AMENDMENTS TO THE DRAWINGS:

REMARKS

The present invention relates to a vehicle hydraulic brake device, and four preferred embodiments thereof are disclosed in connection with Figs. 1-4, respectively. For example, in Fig. 1, a "hydraulic passage" 12 leads from a pressure adjusting valve 3 to wheel cylinders 7-1 and 7-2 (and a hydraulic passage 12, 16 leads from the pressure adjusting valve 3 to wheel cylinders 7-3 and 7-4). A hydraulic pressure supply passage 20 supplies hydraulic pressure from the hydraulic pressure source to the hydraulic passage at a junction J therewith (see the drawing amendment for the reference letter J). A first proportional solenoid valve 21 is provided in the hydraulic pressure supply passage 20 for reducing the output hydraulic pressure of the hydraulic pressure source to a first value before it is supplied to the hydraulic passage 12. A second proportional solenoid valve 22 is provided in the hydraulic passage 12 at a location between the pressure adjusting valve 3 and the junction J. The second proportional valve 22 is operable for reducing the output hydraulic pressure supplied from the hydraulic pressure supply passage. A check valve 23 is provided

Fig.1

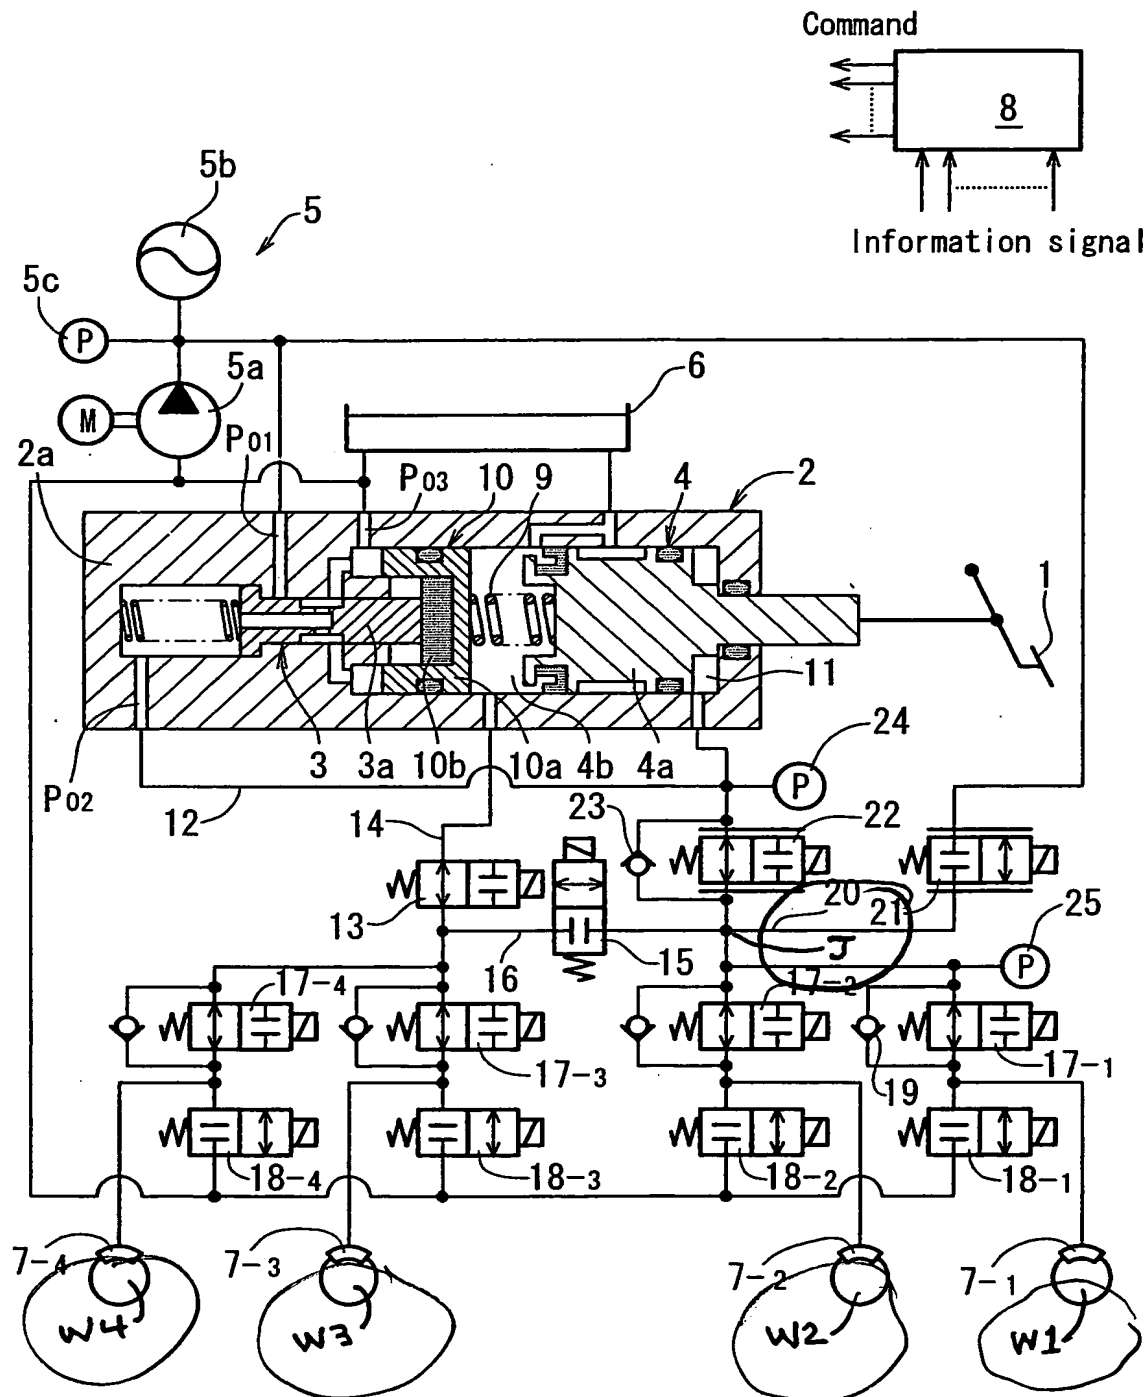
Each of Figs. 1-4 have been amended by inserting "J" and "W-1, W2, W-3, and W-4" therein.
